July 11, 2012

**Re: Storm Water Inspection at Heritage Trail Park-Dog Park- Franklin County  
Permit # 4GC03825\*AG**

Figure 1: Void of any Sediment Controls

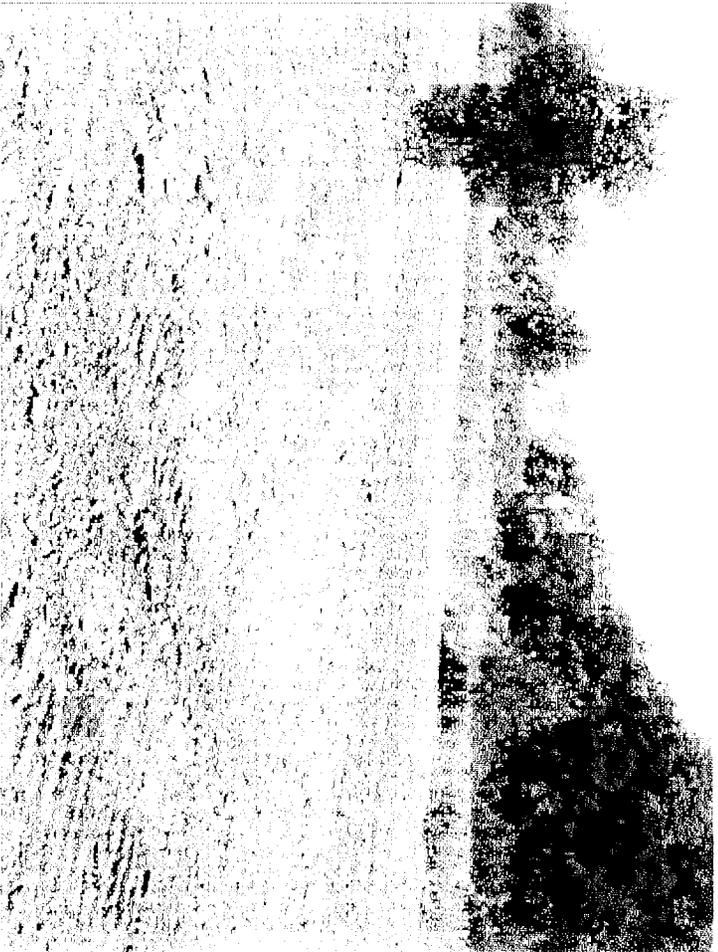
- This site appears to be void of any sediment controls. The General Permit states that all sediment controls must be implemented prior to initial grading of the site. Please implement these controls immediately to ensure compliance with the General Storm Water Permit (Figure 1).
- Be aware the General Permit states that all barren areas which remain idle in excess of 21 days must be protected from erosion within seven days of the last earth disturbing activities. In addition, erosion protection must be implemented for all areas of final grade within seven (7) days (Figure 2).
